# Modification Recommended Service Note

## P5000B Keysight Streamline Vector Network Analyzer

Serial Numbers: From MY61100009 to MY61100135

Potential lifted front panel overlay

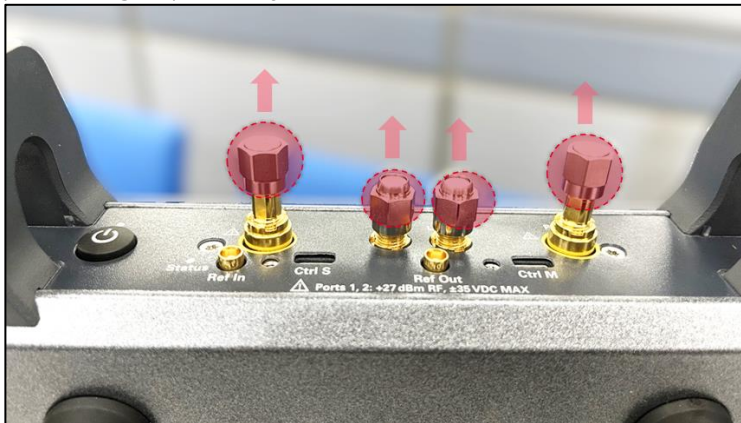
Keysight streamline series vector network analyzer (VNA) of serial number range identified in service note cover page might potentially exhibit the following lifted front panel overlay symptom.

Apart from cosmetic imperfections, the lifted front overlay could have led to non-fully attached *Ctrl S* micro-HDMI cable connector in multi-VNAs setup configuration.

-> Apply this service note only if end users' VNA is exhibiting the following symptom.

Procedure to replace the front panel overlay.

1. Remove the front handles. Detach the 50-ohm termination (LO-In, LO-Out, Port 1 & Port 2) or protecting caps if they are attached to the VNA.

2. Pry open the existing front panel overlay and remove it from front panel.
3. Clean the metal surface thoroughly and ensure it is free of adhesive residue.
4. Affix the new self-adhesive front panel overlay onto the metal surface.
5. Reinstall (reuse) the 50-ohm terminations and port protecting caps accordingly.

6. Reinstall (reuse) the front handles.
